# I-25 at US 50 Interchange Reconstruction (PN 23255)

Final Value Engineering Report

Colorado Department of Transportation

December 2021

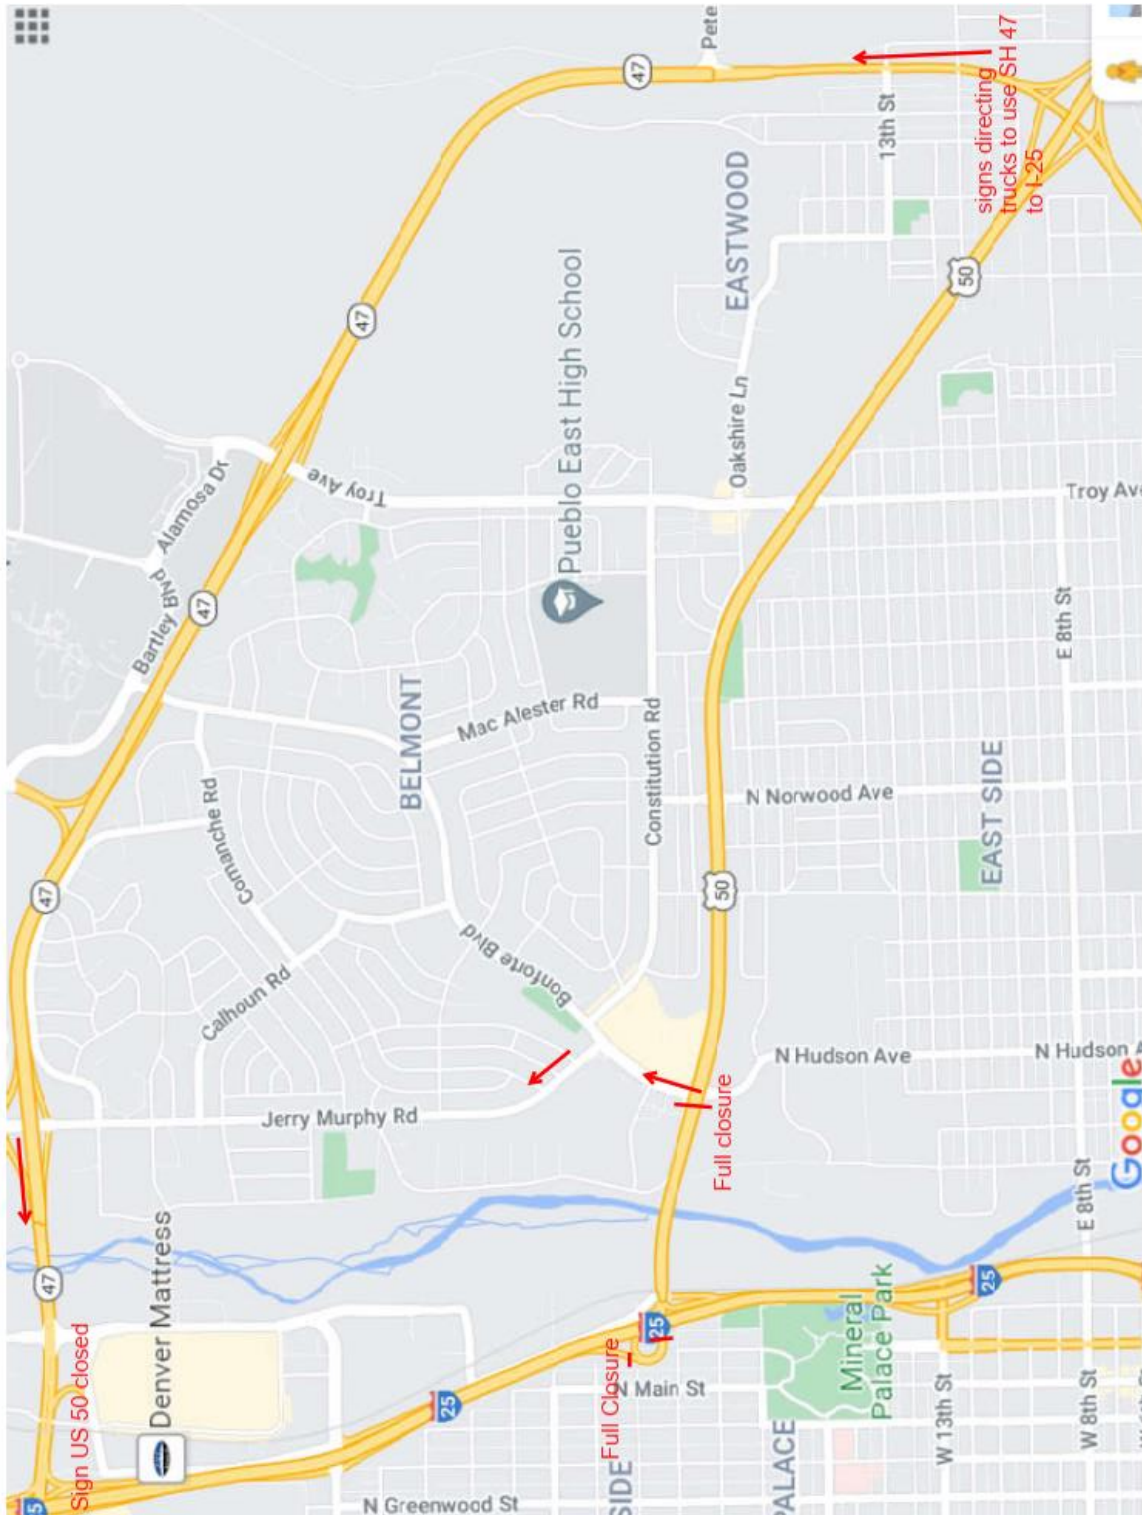
| Activities planned to take place within closed area:                            | Bridge and roadway construction |

| Roads to be used:  | SH 47 for trucks. Bonforte Blvd for locals        |

2. How might the closure affect emergency response? **Will increase response time to I-25**

The comparable length detour onto a lower classification roadway could cause minor delays for emergency response.

# CM-11 Quantitative Value Alternative

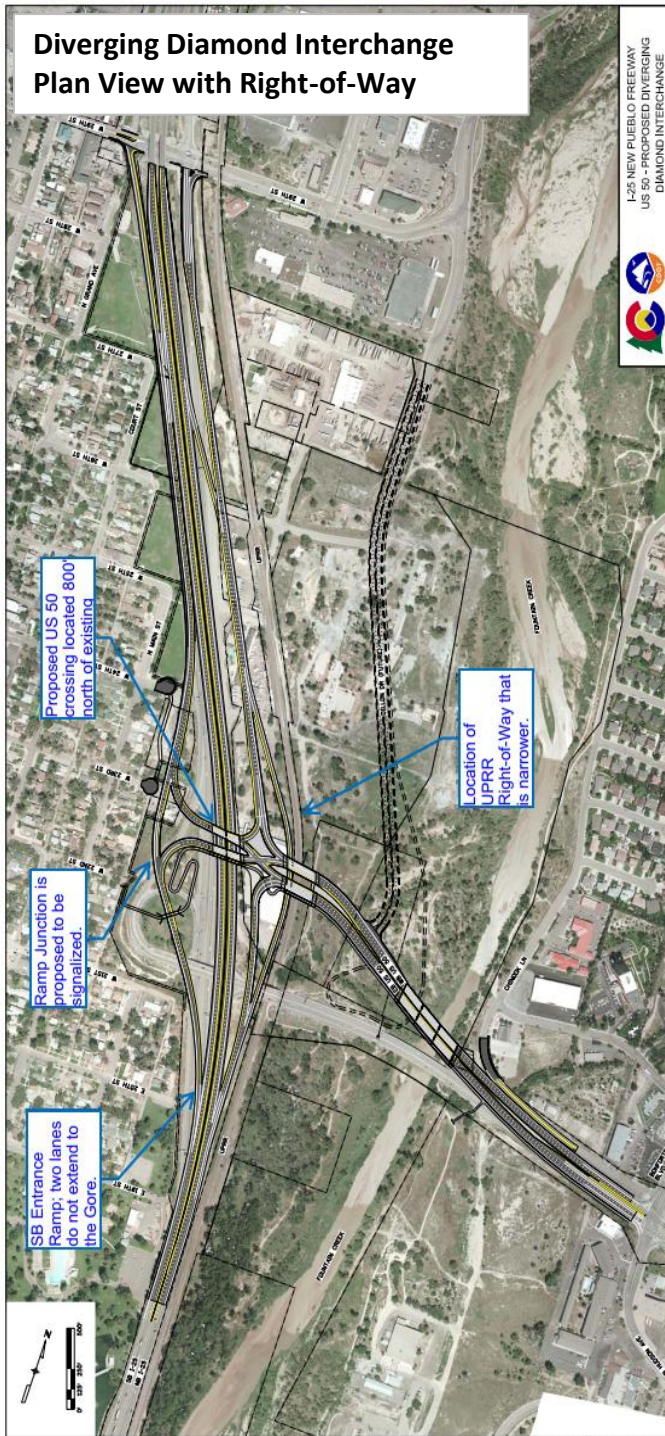
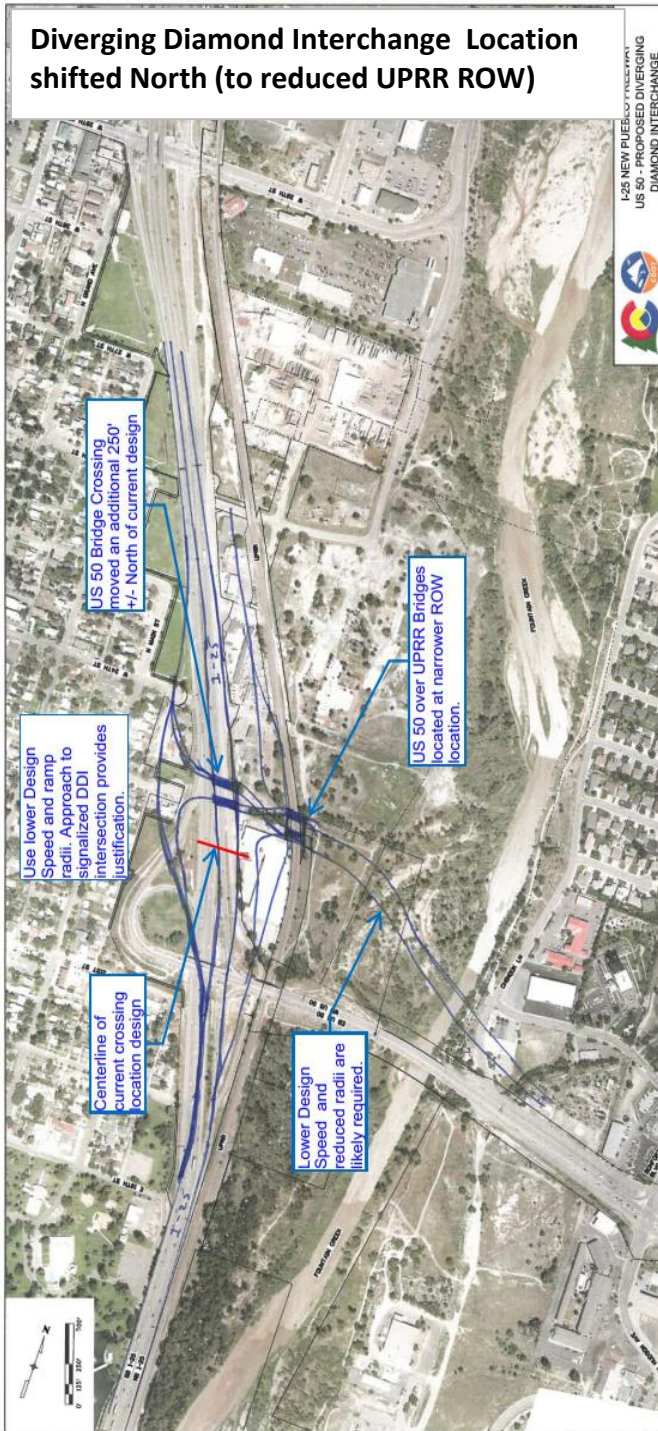
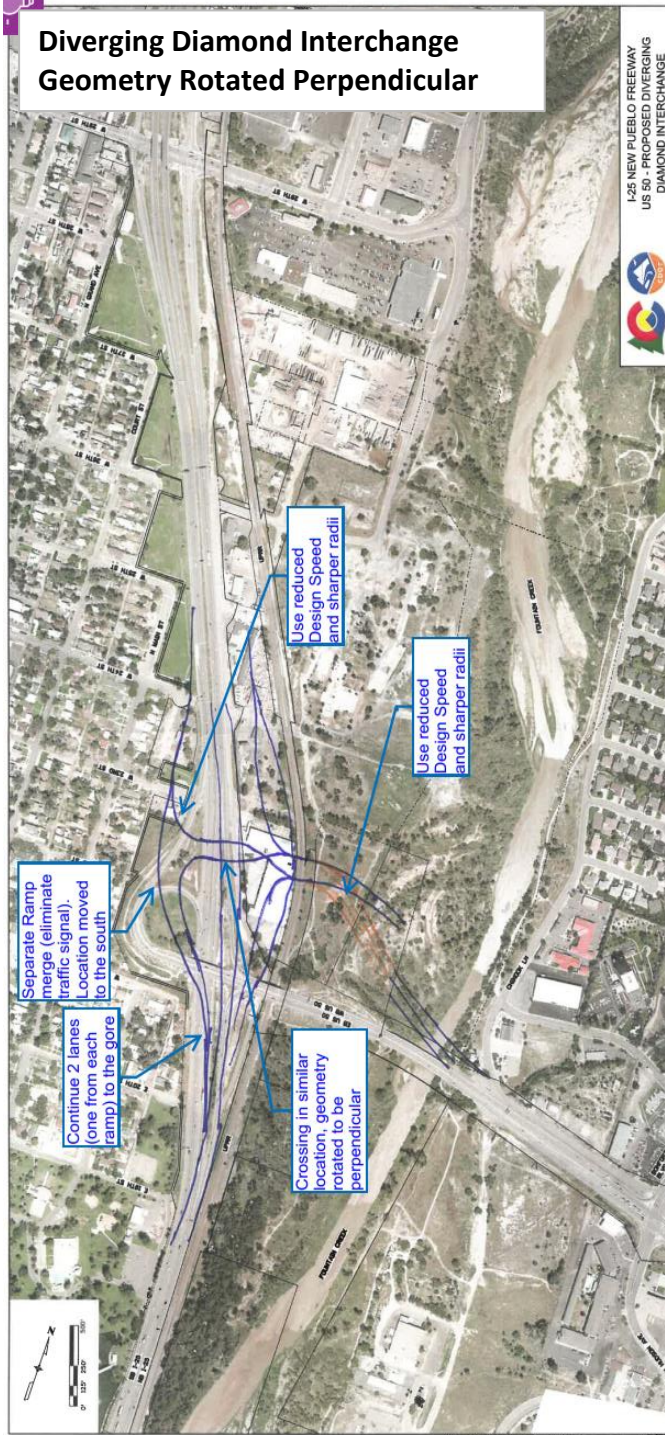
- CM-11 Move US 50 Crossing Over UPRR to the North and Align Perpendicular**  
Realignment of the US 50 bridge from skew to perpendicular over the UPRR would reduce bridge length, improve ramp geometrics, and potentially reduce right of way impacts. However, realignment would increase horizontal curvature to bridge approaches and add superelevation transitions across the bridge structures.

- Added / increased horizontal curvature
- Added superelevation transitions across bridge structures

The Alternative Concept should be discussed with UPRR for confirmation. There is also the possibility of designing a similar concept with the current US 50 horizontal alignment that would place the east abutment inside the UPRR ROW. This would require an agreement with UPRR.

Figure 1

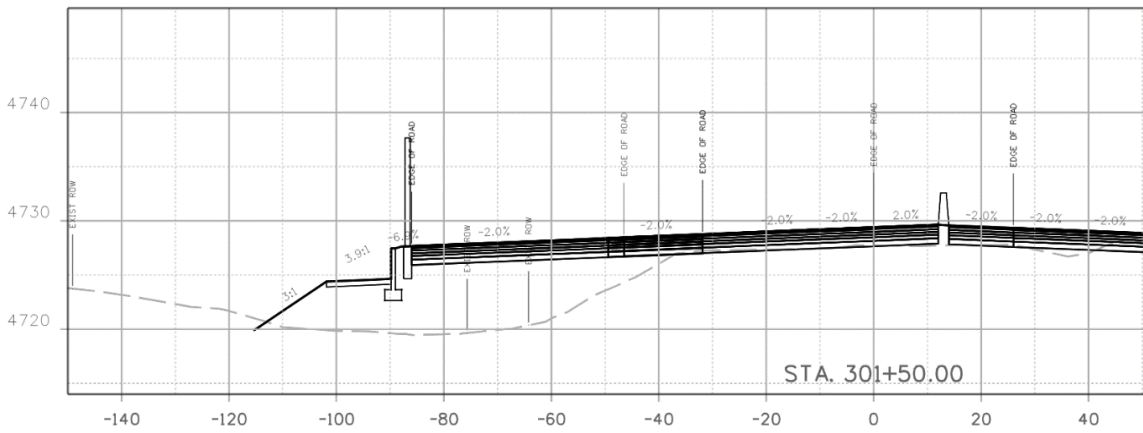
Utilize retaining wall to provide grade separation between path and ramps. Some of the retaining walls are short with an approximate height of 5-feet. Typical section of the short wall structures are shown in Figure 1.

Figure 2

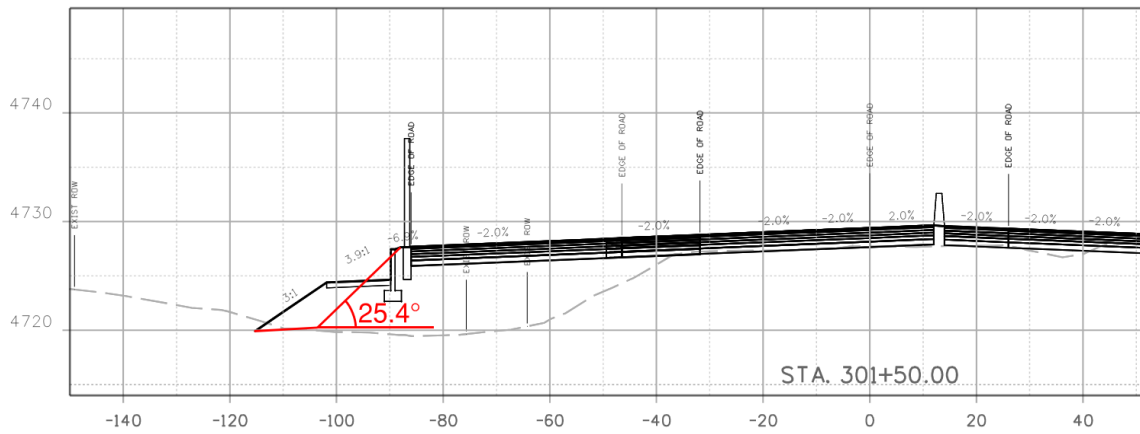
Move the location of the path, steepen the slope and manage the material types used for the embankment, and eliminate the needs of retaining walls. Typically CDOT Class 1 materials can supports slope as steep at 2.5H:1V. See Figure 2.

| ID No.                | Alternative Title  | Alter. Cat. | Mut. Excl. | Incl. (i) | Potential Costs (\$) |          |                 | Cons. Dec. | Consensus Comments   | Key Alter. | Decision Makers |
|-----------------------|--|-------------|------------|-----------|----------------------|----------|-----------------|------------|--|------------|-----------------|
| <a href="#">CM-22</a> | Steepen Slopes; Eliminate Short Retaining Walls  | Qnt(+)      |            | i         | \$ 107,200           | \$ -     | \$ 107,200      | R          | Slope criteria is based on plant growth and maintenance.     |            | Owner, Designer |

# CM-24 Quantitative Value Alternative

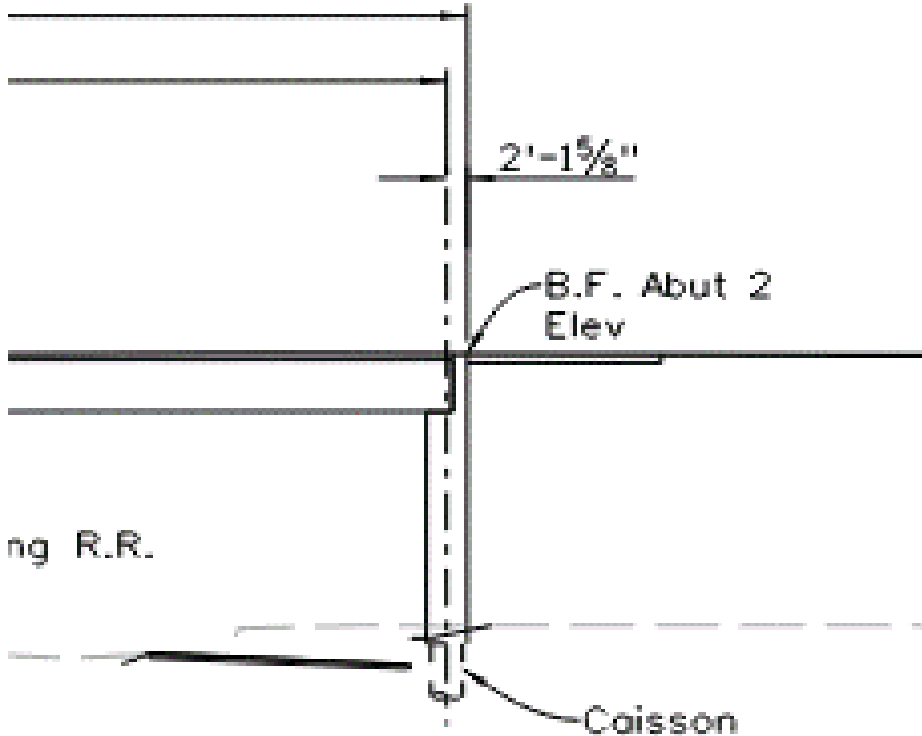
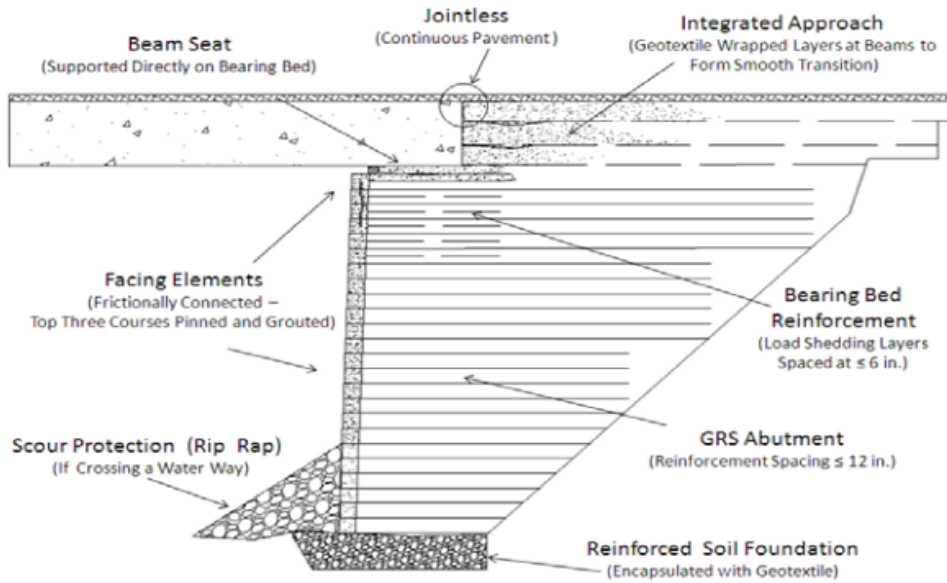
- CM-24 Use Geosynthetic Reinforced Soil Integrated Bridge System**  
Use of geosynthetic reinforced soil integrated bridge system for abutments may eliminate deep foundations, simplify construction, reduce construction costs, and reduce construction schedule. However, settlement would have to be considered during abutments design.

- Settlement has to be considered in the design of the abutments.

This is a CDOT Staff Bridge approved system, that greatly reduces foundation costs. This system works well with short bridges supported behind MSE retaining walls. CDOT just uses this system at their new I-70/Colfax bridge replacement.

## ES-12 Quantitative Value Alternative

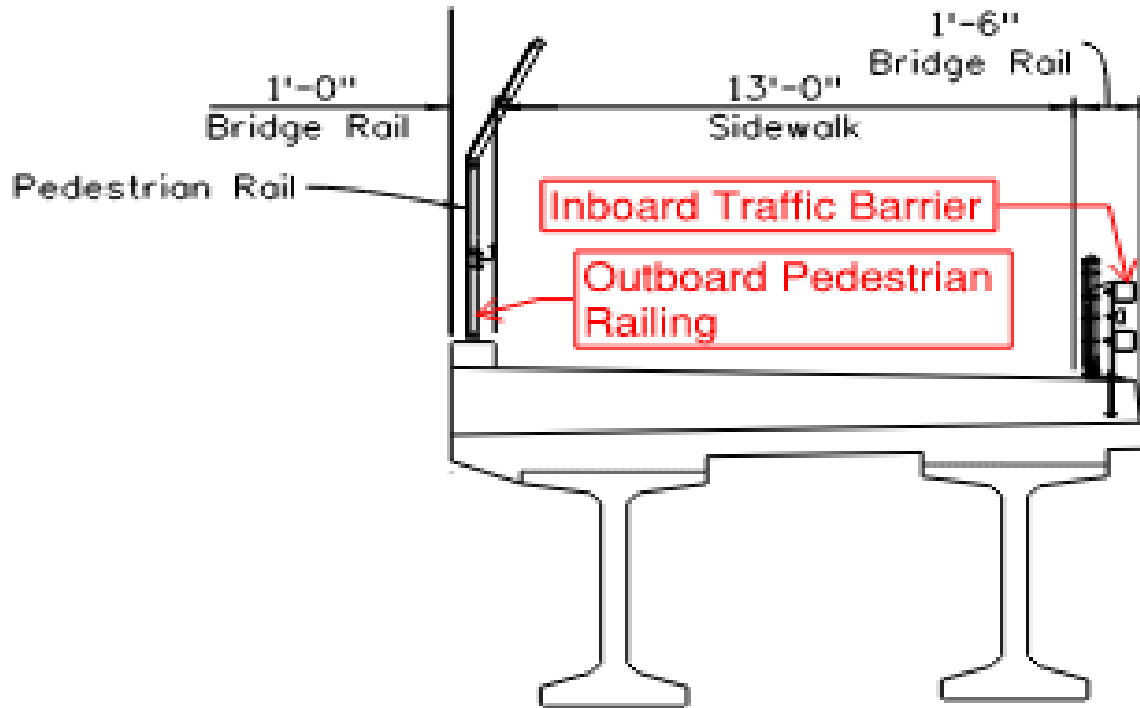
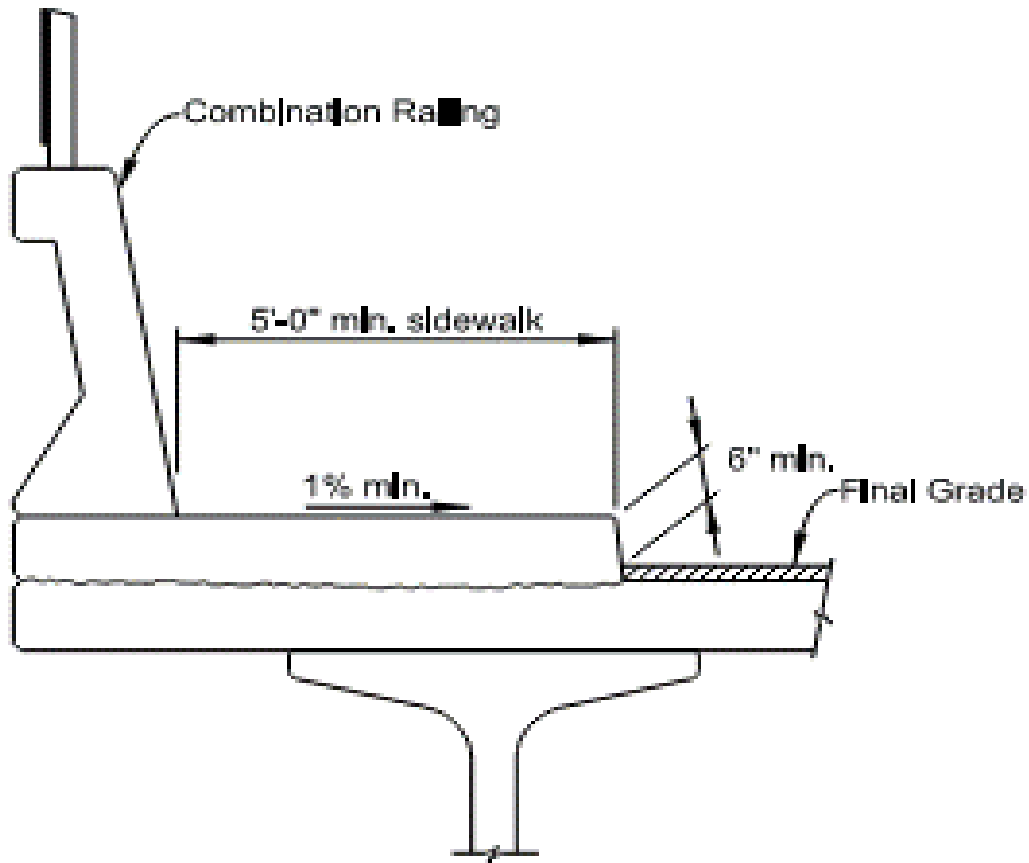
- ES-12 Move Bridge Rail from Inside Sidewalk Edge to Outside Edge of Bridge; Use Barrier Curb**  
Moving the bridge guard rail to the outside edge would reduce bridge width, simplify bridge deck and superstructure construction, and simplify the approach guardrail layout. However, placement of the guard rail along the inside sidewalk edge provides better separation between pedestrians and vehicles on the bridge.

- The original concept provides better separation between pedestrians and vehicles.

The alternative concept will simplify construction and reduce project costs. The low pedestrian traffic coupled with the low vehicle speeds could justify this reconfiguring.

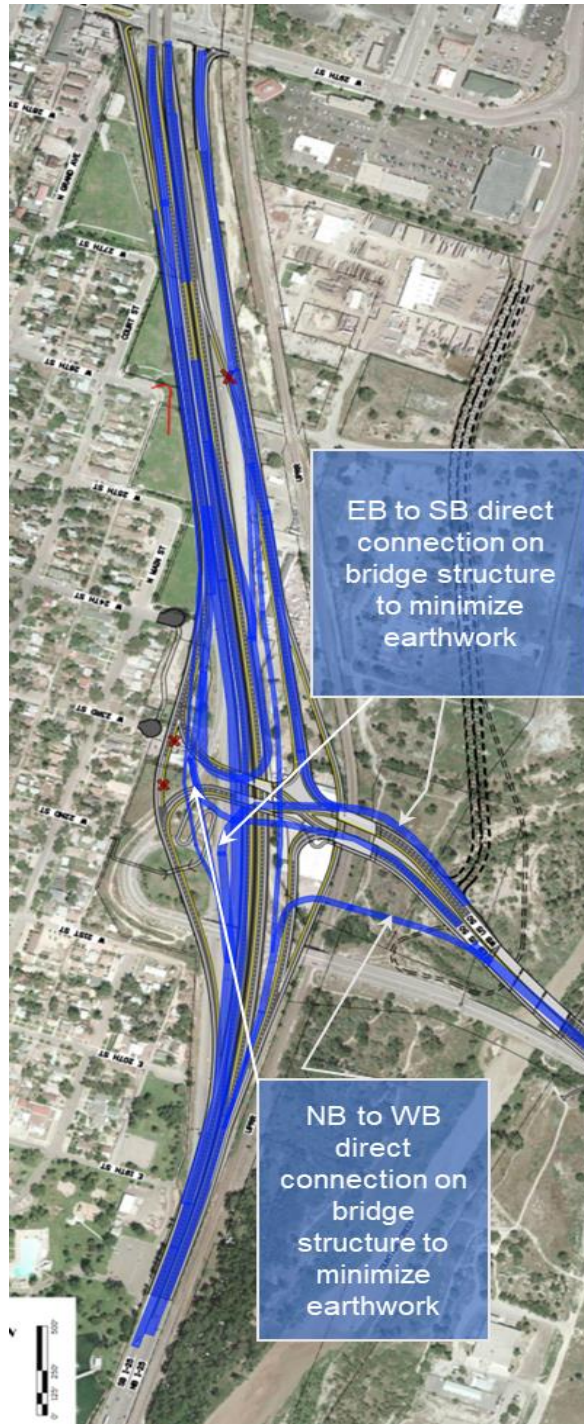
- IM-02 Eliminate DDI, Build Flyovers**  
Use of direct connector flyovers would reduce impact to the Fountain Creek floodplain, reduce volume of imported fill, allow for higher speeds through the interchange, eliminate signalized traffic movement thereby reducing conflict points, and may improve construction phasing. However, flyovers would have significantly greater visual impact and would increase overall construction cost.

The existing interchange condition at I-25 and US 50 has no traffic signals. The purpose of this alternative is to add direct connectors to eliminate traffic signals. This would be accomplished with grade separated structures.

- There may significant cost impacts associated with added bridge, but part of this would be offset by reduced fill in the Fountain Creek channel and floodplain.
- The resulting interchange will be higher in elevation and could have a larger visual impact.

With this alternative, there would be direct connector bridges for the WB US 50 to SB I-25 and for the SB I-25 to EB US 50 movements. This results in the removal of the base concept DDI and its two traffic signals. The crossings of the direct connectors would also be grade-separated adding a third level to the interchange, one level more than the base design.

The direct connectors would be primarily installed on bridge structures and this will reduce the amount of fill and channel disruption. As the direct connectors would be at a higher elevation than the SB to NB U-turn loop from 29th Street, there would need to be constructed a separate bridge over I-25 for this movement.
